SUBMISSION ON PROPOSED TE TAI O POUTINI PLAN (TTPP)

3.0 SUBMISSION

1. Griffen & Smith Ltd own and operate the Mitre 10 Mega store located on Waterwalk Road, Greymouth. Under the operative Grey District Plan, the site is zoned Rural Environmental Area; under the proposed Te Tai o Poutini Plan, the site is to be rezoned as COMZ – Commercial Zone.

TTPP Overlay Maps

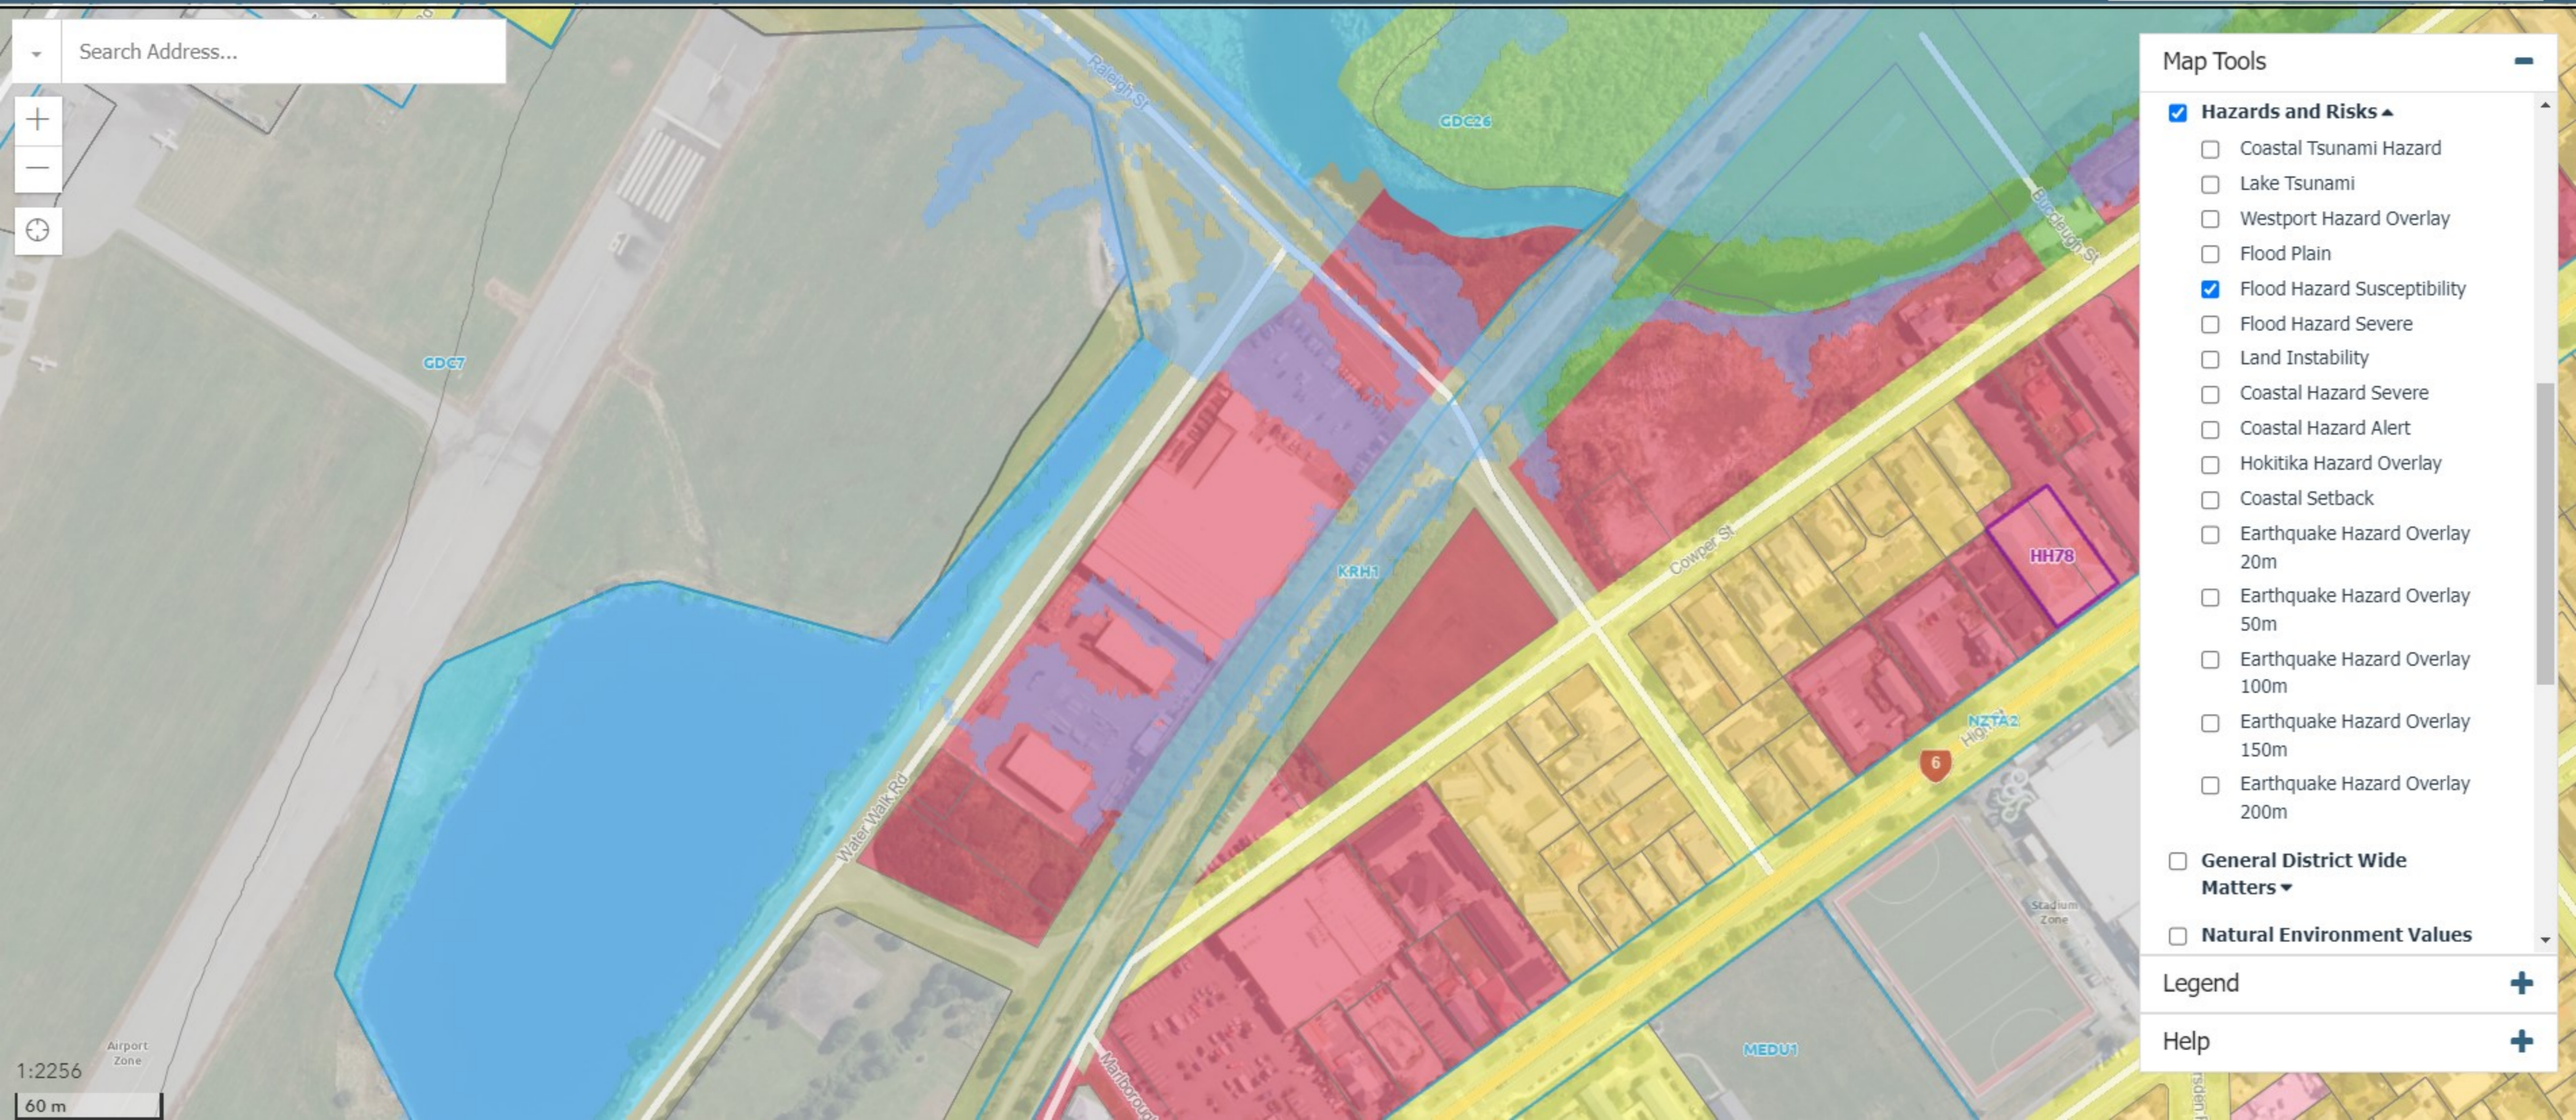
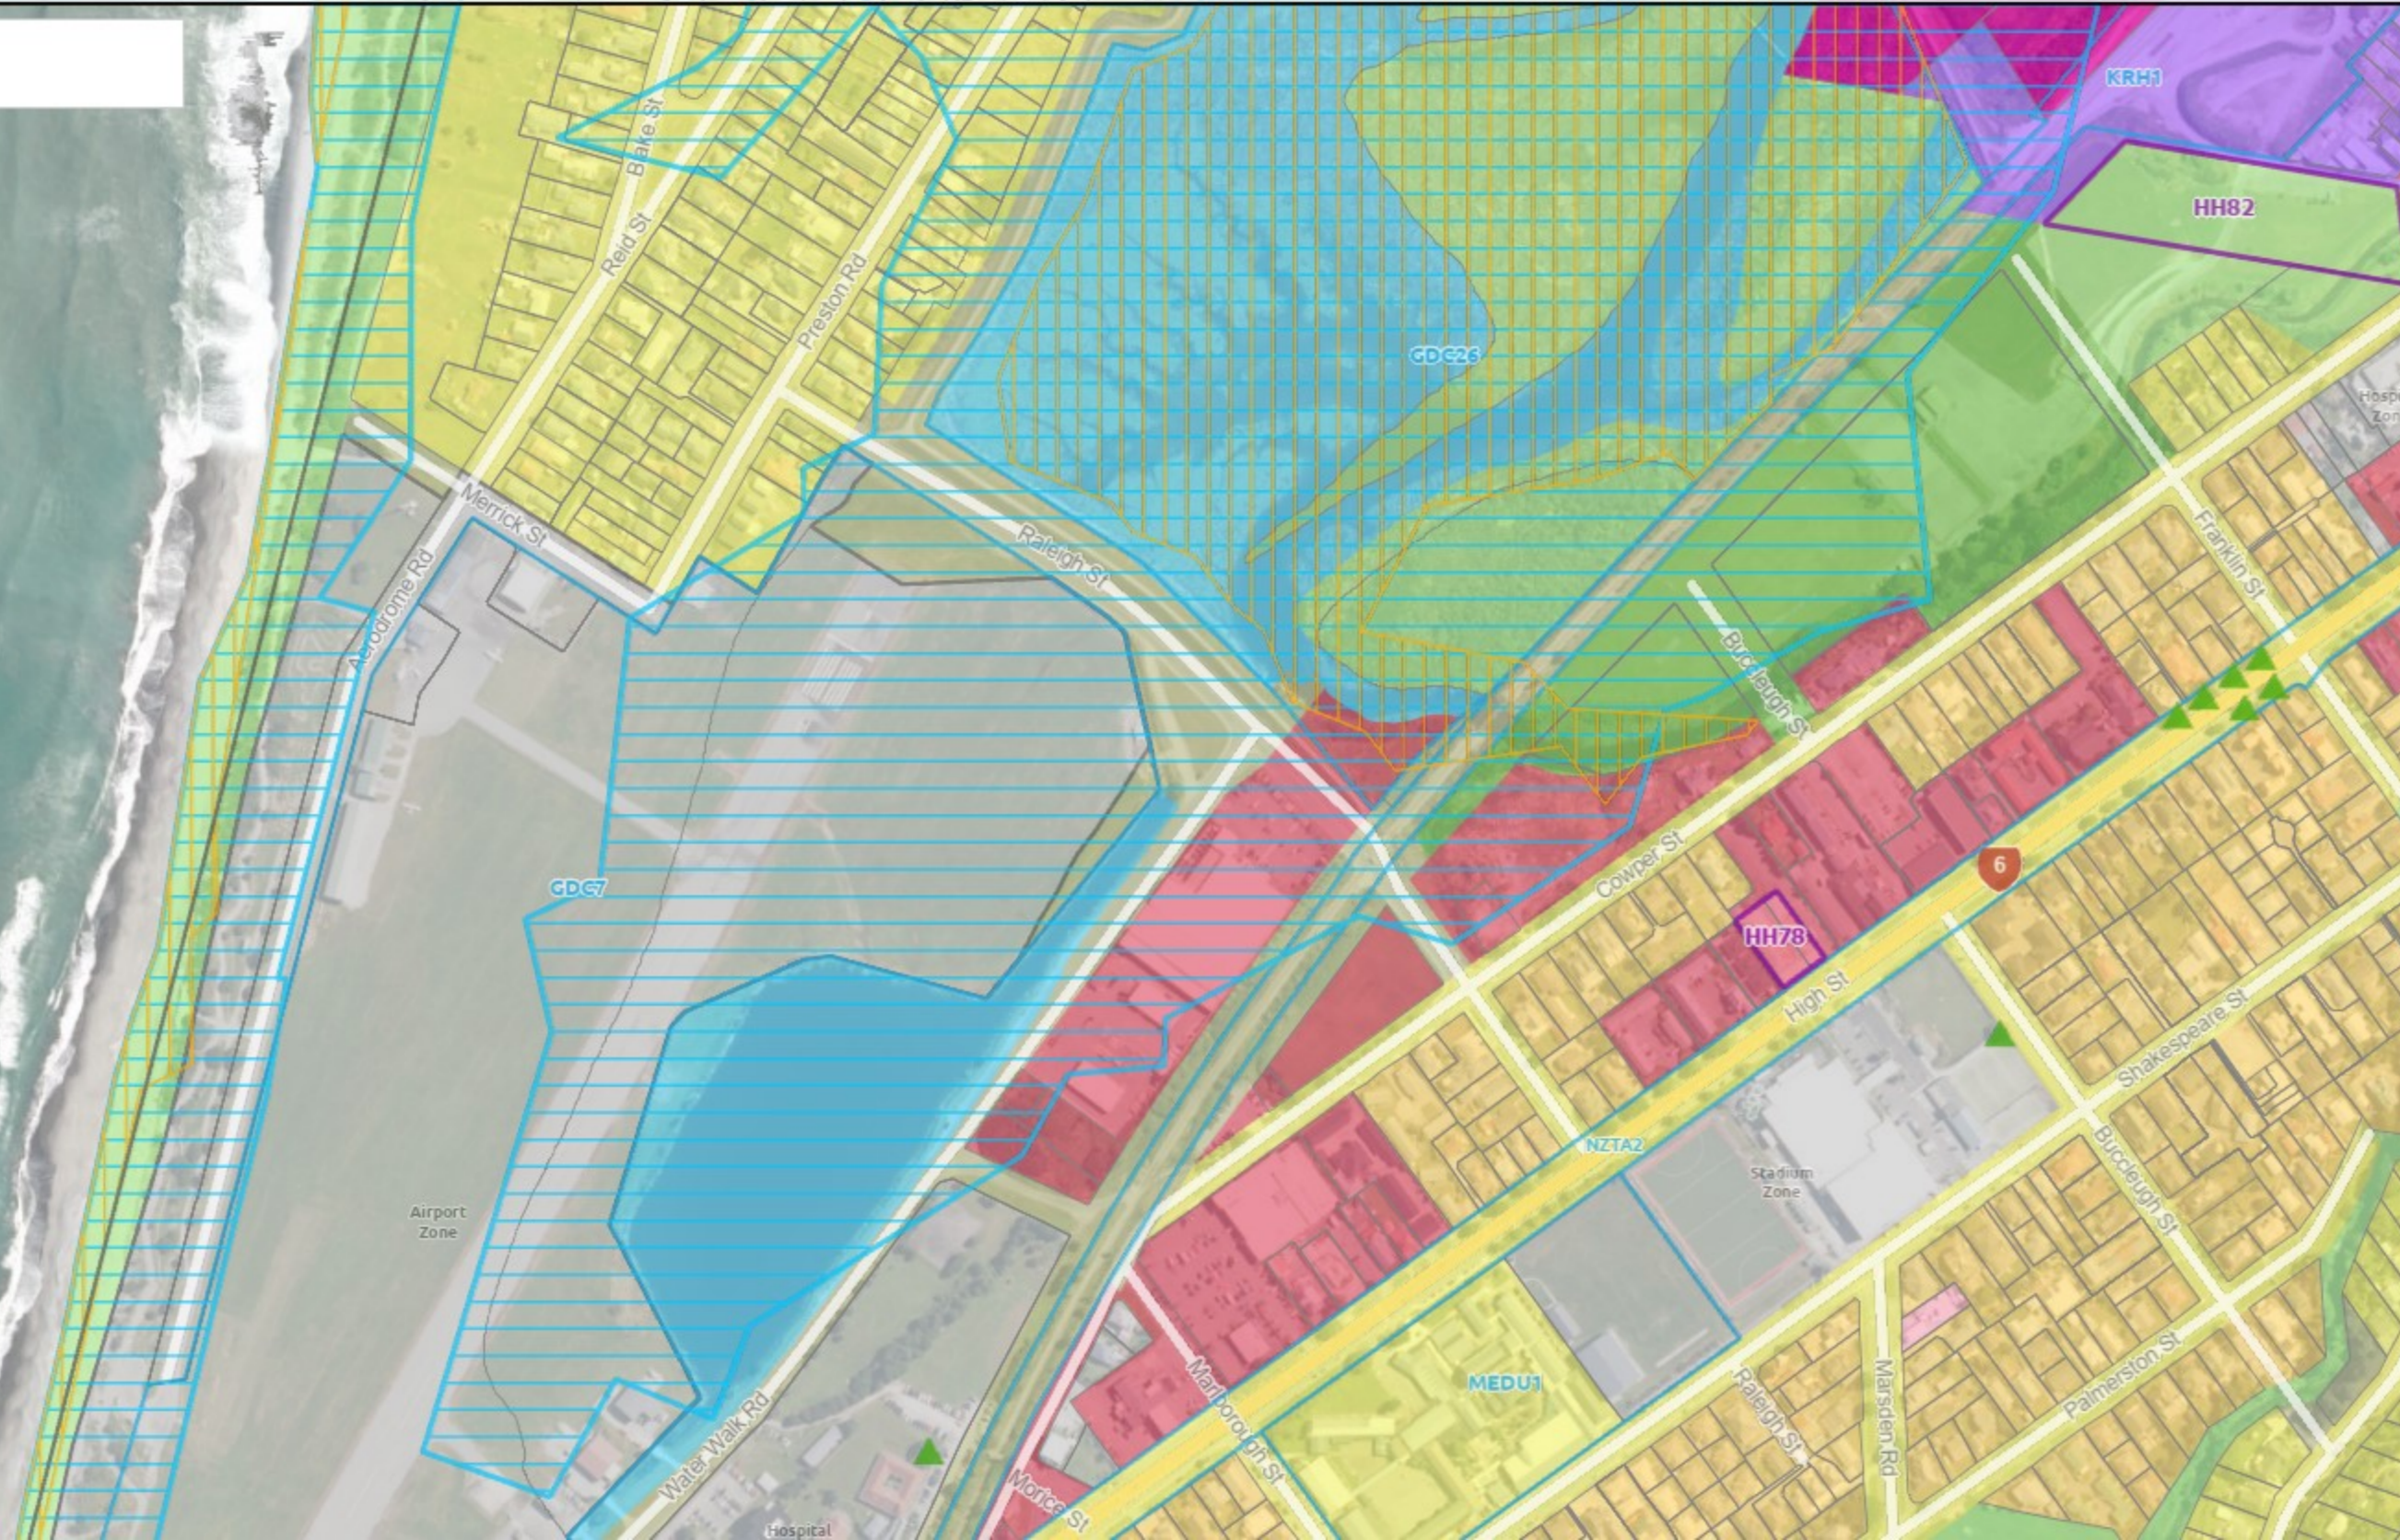
11. **Appendix 1** contains two printouts from the TTPP mapping system showing potential hazard overlays in the vicinity of the Mitre 10 Mega site:
 - (i) Showing the **Flood Hazard Susceptibility** (solid purple) overlay

- (ii) Showing the **Coastal Hazard Alert** overlay (horizontal blue hatching) and the **Coastal Tsunami Hazard** overlay (vertical yellow hatching).When viewed at a larger scale, all three overlays appear to model flooding from Erua Moana Blaketown Lagoon rather than directly from the coast.

12. The **Flood Hazard Susceptibility** overlay excludes the buildings on the Mitre 10 site, and is therefore generally acceptable to Griffen & Smith.
13. It is noted that in all natural hazard overlay areas, existing buildings can be replaced if destroyed or damaged by fire, natural disaster or Act of God (Rule NH – R1); and that new unoccupied buildings or additions/alterations for buildings for commercial/industrial activities can be constructed as a permitted activity in the Flood Susceptibility and Coastal Alert overlays providing finished floor levels are 300mm above a 1% AEP flood event (Rules NH – R7, R8, R39 and R40). These rules are supported by Griffen & Smith, taking into consideration that the 1% AEP level may change over time.

14. The **Coastal Hazard Alert** overlay covers most of the Mitre 10 Mega site, including the main shop building and the large storage shed in the yard. Griffen & Smith object to this overlay affecting their site. They submit that the boundary of the overlay appears arbitrary, being “straight-lined” through their site, and has potential to unfairly affect their insurance cover in future.

15. Griffen & Smith note that the overlay excludes the buildings on the western side of Waterwalk Road south of the lagoon, and submits that these buildings are more likely to be inundated in the event of a coastal surge due to their location near the lagoon.

22. Furthermore, the Coastal Hazard Alert overlay does not appear to account for the protection afforded by the Greymouth Flood Wall, including floodgates designed to stop water from flowing along the railway line and/or backing up through the culvert under Raleigh Street into the lagoon. In the event of a major coastal inundation threat (storm or tsunami), it would be expected that Council would take steps to protect property and minimise inundation. This would include moving the large concrete floodgates into position at the railway line, and closing the lagoon inlet/outlet floodgate; both of which would protect the Mitre 10 Mega site along with other properties on Waterwalk Road.

23. We note that the Coastal Tsunami Hazard overlay does take into consideration the Greymouth Flood Wall system; this overlay does not extend past the flood wall along Raleigh Street (refer printout attached as **Appendix 1**). The two coastal overlays appear inconsistent, when conceivably they should be similar in extent in areas that are protected by the Greymouth Flood Wall.

24. Griffen & Smith request that the Coastal Hazard Alert overlay be removed from their site.

LIDAR Elevations Plan

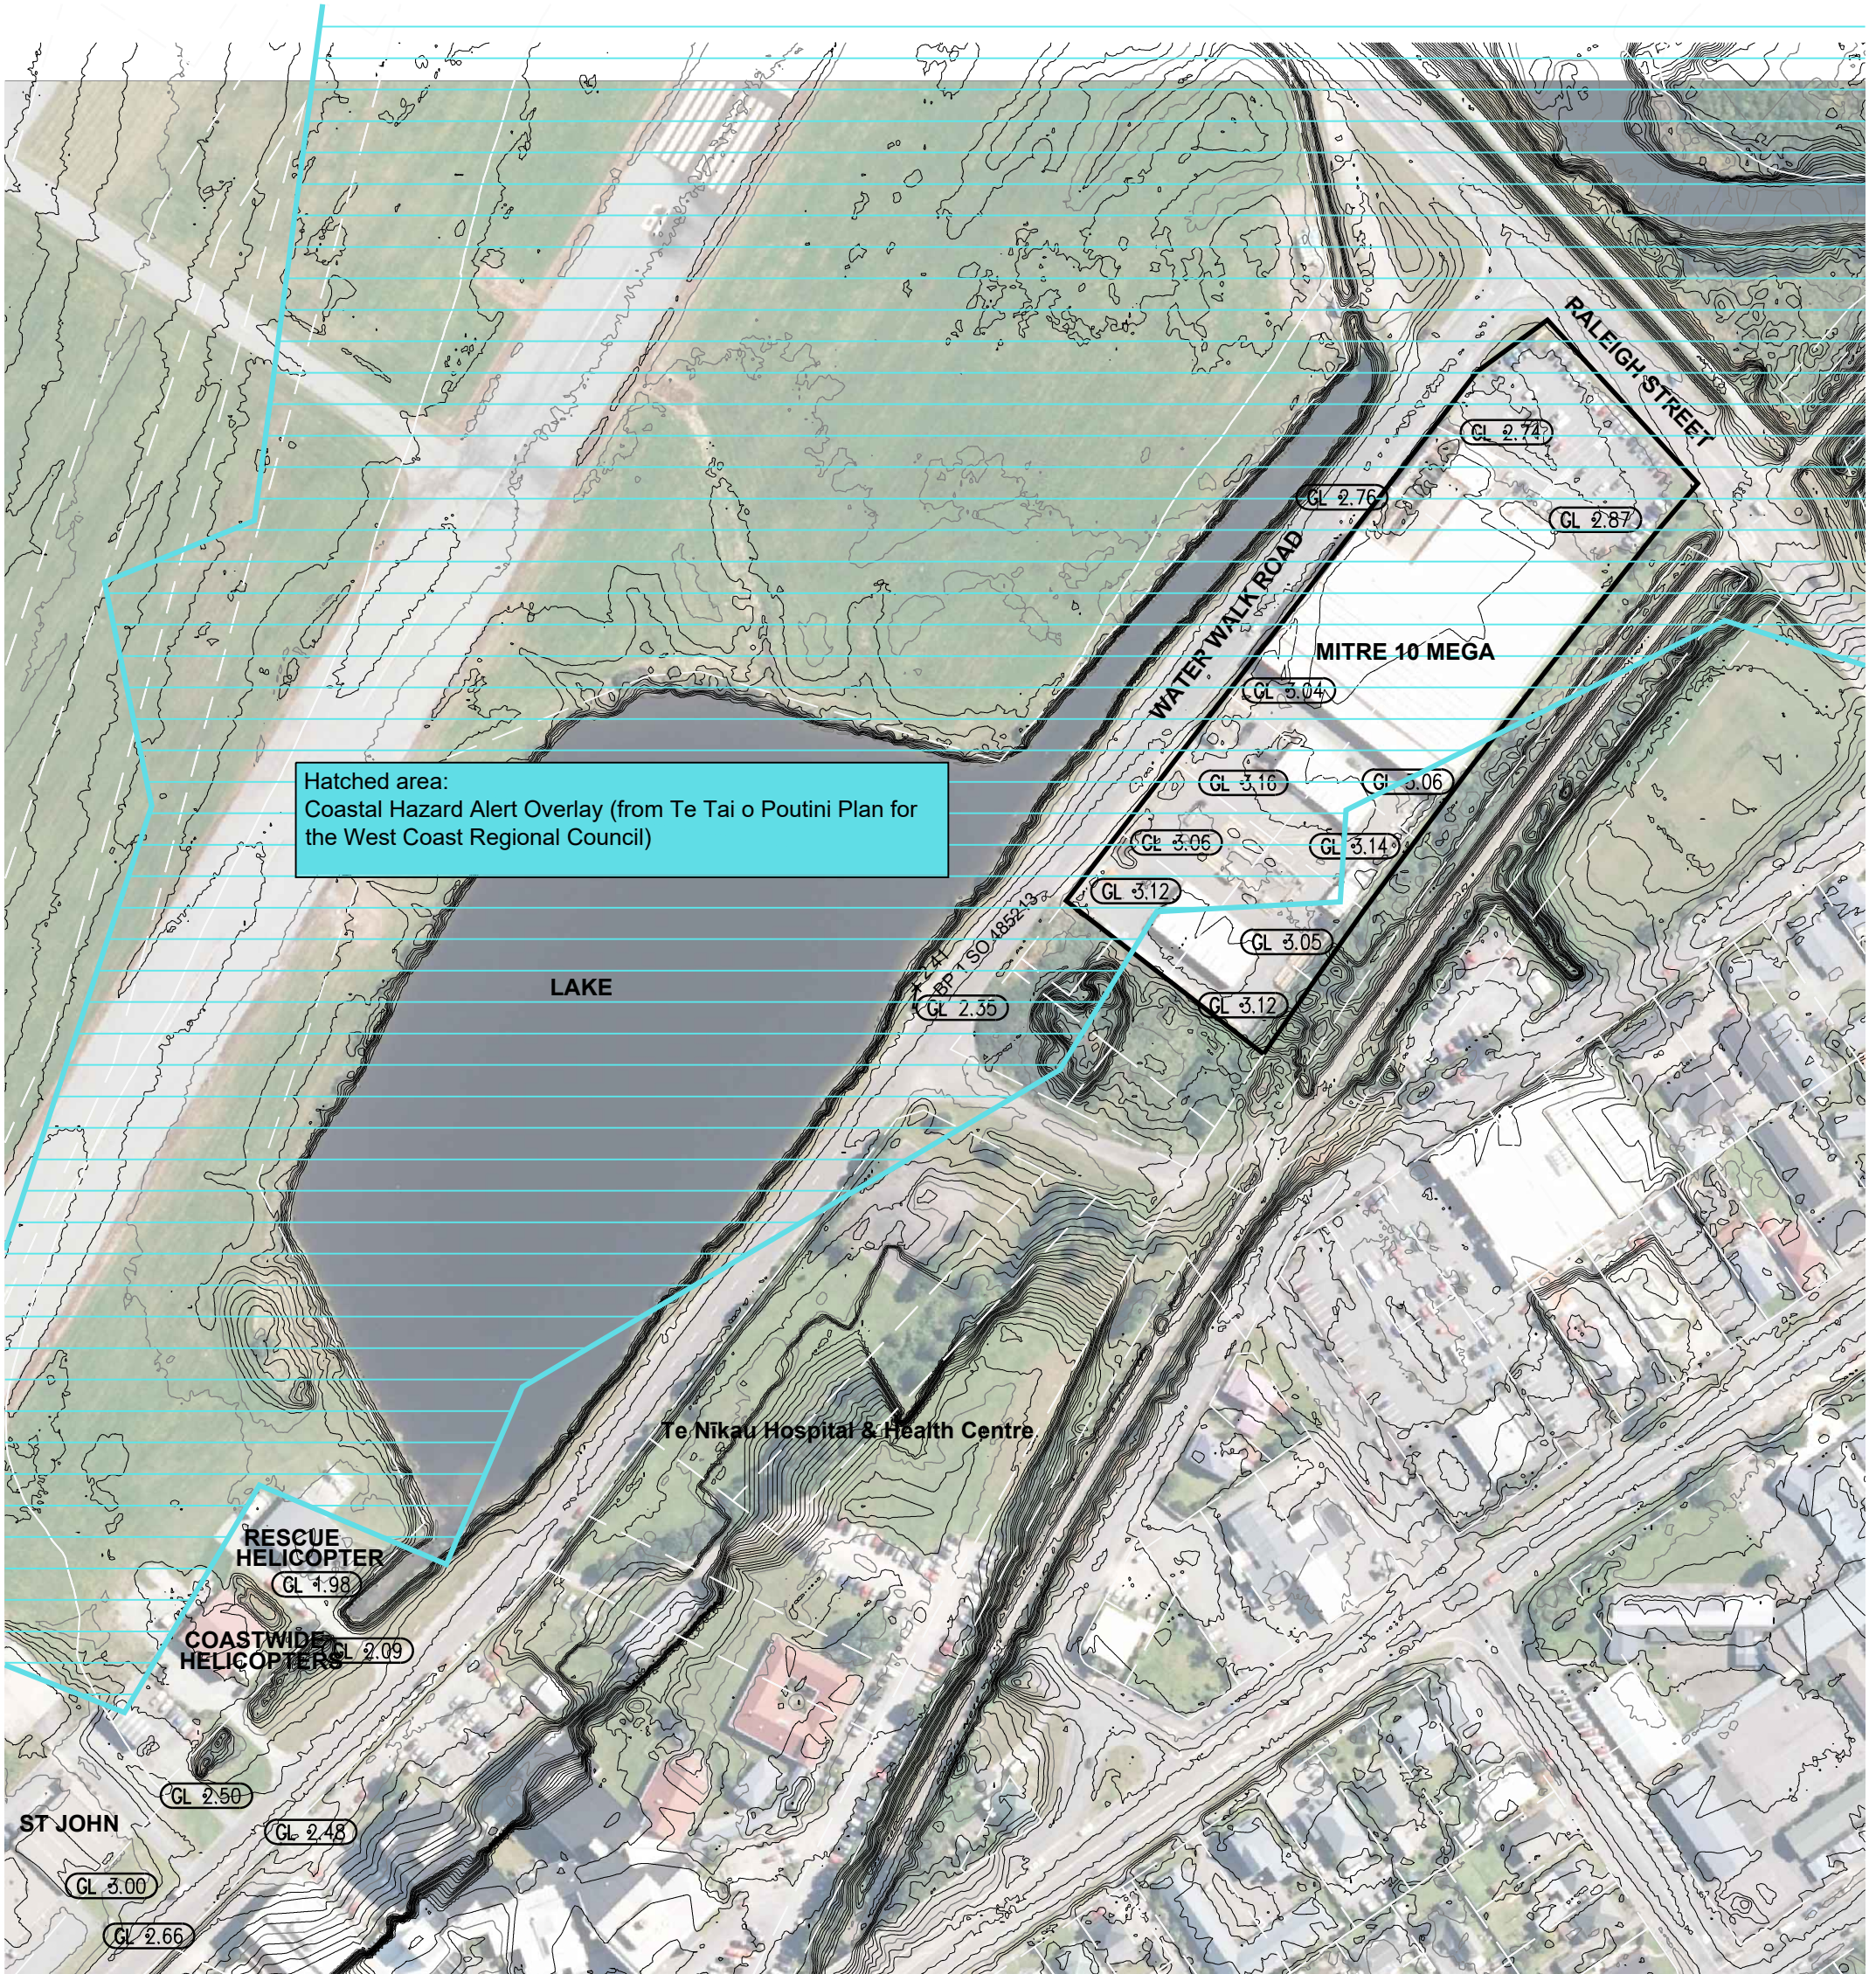
16. **Appendix 2** contains a plan showing ground levels along Waterwalk Road extracted from Council’s LIDAR data. The plan shows that ground levels across the Mitre 10 site range between 2.74m (at the car park) and 3.16m (in the trade yard). Ground levels at the “excluded” properties further along Waterwalk Road are considerably lower, at 1.98m and 2.09m.
